HISTORIC AND DESIGN REVIEW COMMISSION

HDRC CASE NO: 2017-087
ADDRESS: 355 E KINGS HWY
LEGAL DESCRIPTION: NCB 6327 BLK 2 LOT W 39.70' OF E 45' OF THE S 100' OF 56 & SW TRI 34.32' OF 57
ZONING: R-5, H
CITY COUNCIL DIST.: 1
DISTRICT: Monte Vista Historic District
APPLICANT: Stephen Reyna
OWNER: Sam Asvestas
TYPE OF WORK: New Construction
REQUEST:

The applicant is requesting a Certificate of Appropriateness for approval to:

PROPOSED SITE PLAN

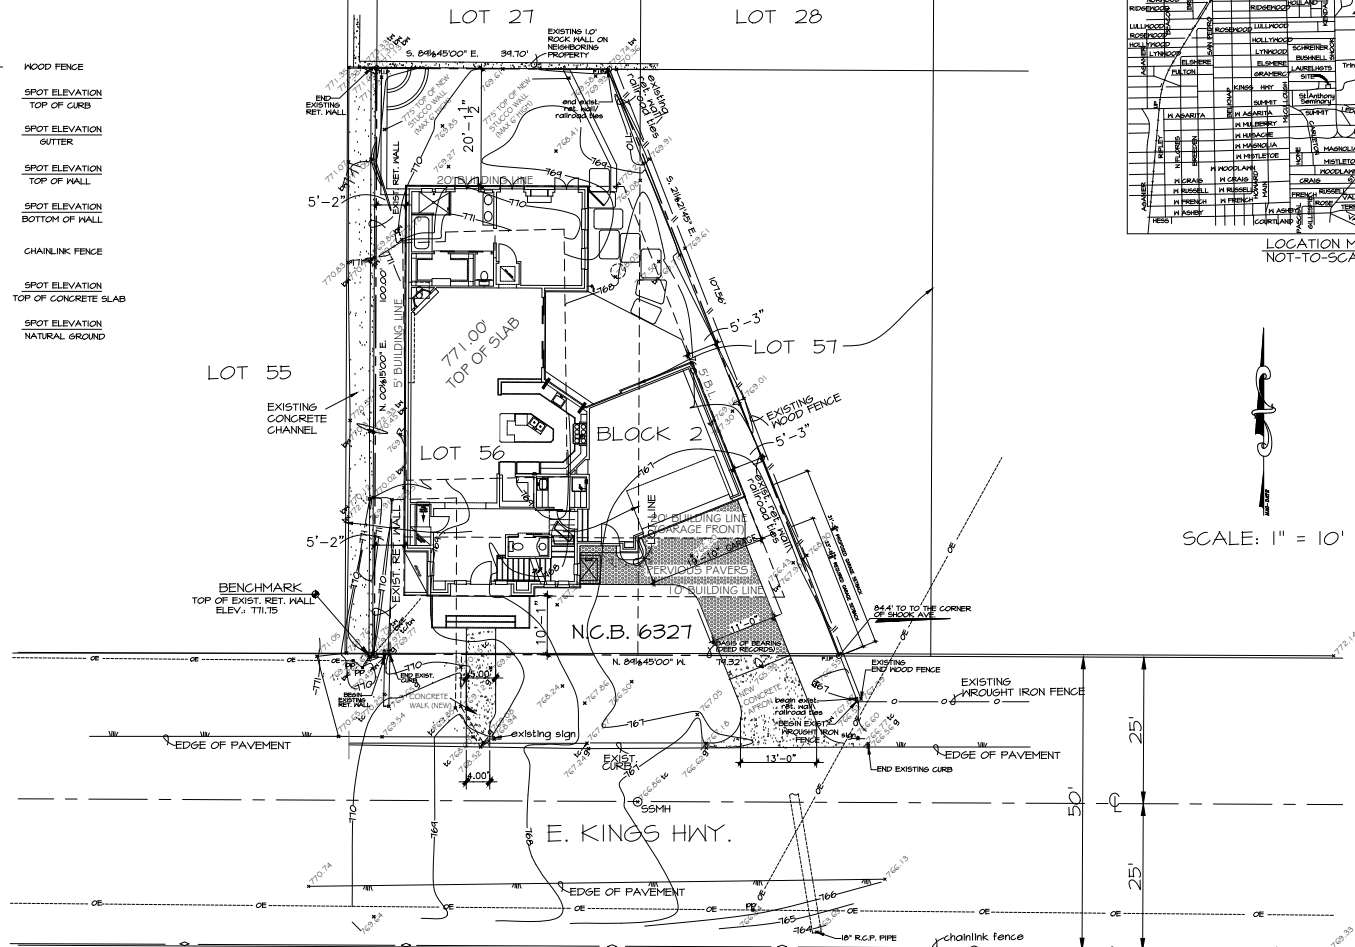
- a. **SETBACKS & ORIENTATION** – According to the Guidelines for New Construction, the front facades of new buildings are to align with front facades of adjacent buildings where a consistent setback has been established along the street frontage. Additionally, the orientation of new construction should be consistent with the historic example found on the block. The proposed setback of 10 feet from the property line is consistent with other residential structures along the block.

- g. **LOT COVERAGE** – According to the Guidelines for New Construction, 2.D.i., the building footprint for new construction should be no more than fifty (50) percent of the size of total lot area. The proposed building footprint is approximately 50% of the lot area, which is consistent with the Guidelines.

- l. **DRIVEWAY** – According to the Guidelines for Site Elements, driveways generally in historic districts are no wider than 10 feet. The proposed driveway is 11’ wide screened by plantings. Staff finds the proposed driveway width is consistent with the historic development pattern in this district and that the pervious pavers are appropriate material.

- m. **WALKWAY** – The proposed front yard walkway leads from the front porch to the public right of way and is 5’ wide. According to the Guidelines for Site Elements 5.A., new walkways should follow the historic alignment, configuration and width of sidewalks and walkways. Staff finds front walkways found historically throughout the district are 4’ wide. A 4’ wide concrete walkway would be appropriate.

- 1. That the galvalume standing seam metal roof use panels that are 18 to 21 inches in width, ensure seams are an appropriate height for the slope of the roof (1 to 2 inches), and use a crimped ridge seam that is consistent with the historic application or a low profile ridge cap with no ridge cap vent or end cap, when a crimped ridge seam is not used.
- 2. That the front concrete walkway is 4’ wide.
- 3. That the mechanical equipment be noted on the plans and be screened from the public right-of-way.
- 4. That a landscape plan be submitted to staff consistent with the Guidelines for Site Elements 3.A. as noted in finding o.

Head Jamb and Sill **#3**

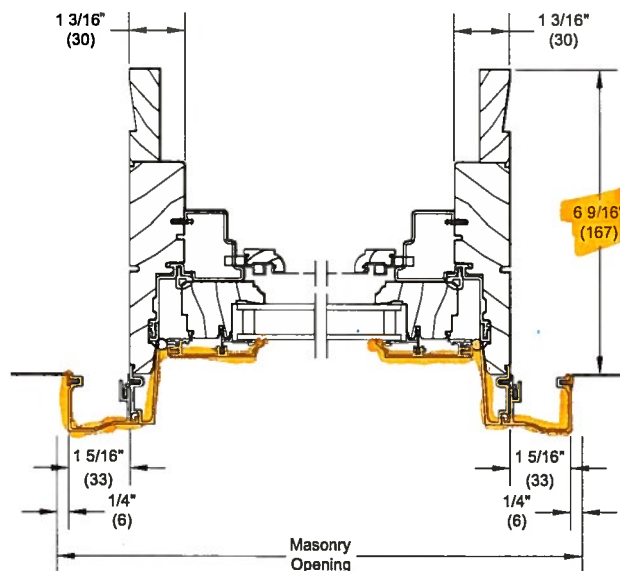
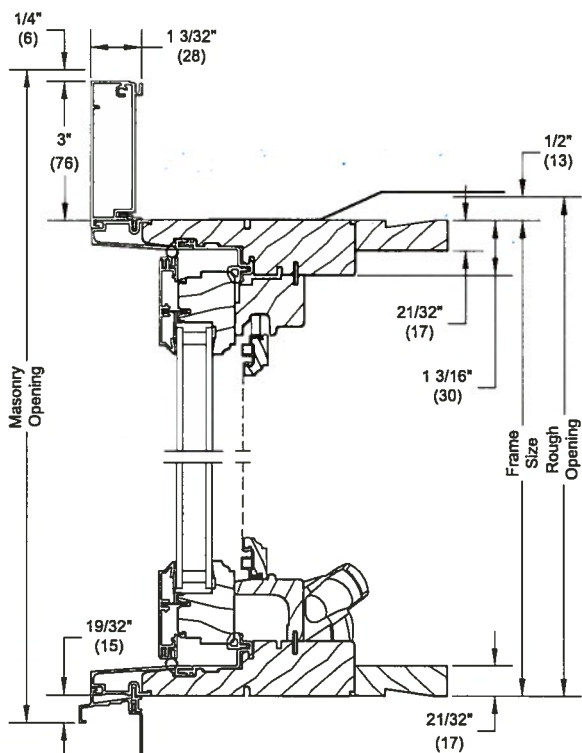
- i. **WINDOWS** - The proposed one over windows are proposed to be made of aluminum clad. According to the Guidelines for Windows, windows of an alternative material may be considered; windows must maintain traditional dimensions and profiles that are recessed within the window frame, and that feature traditional trim and sill details. Staff finds there is sufficient documentation to display that the proposed aluminum clad windows will be installed consistent with the Guidelines and maintain the traditional appearance of historic wood one over one windows.

As you can see in the attached Section details highlighted in orange, the aluminum clad windows match almost identically to the all wood windows including the depth of the window relative to the frame edge, the sloped sill, and the butt-jointed window frame.

Compare #3 on page 1 with #3 on page 2
#4 on page 1 with #4 on page 2
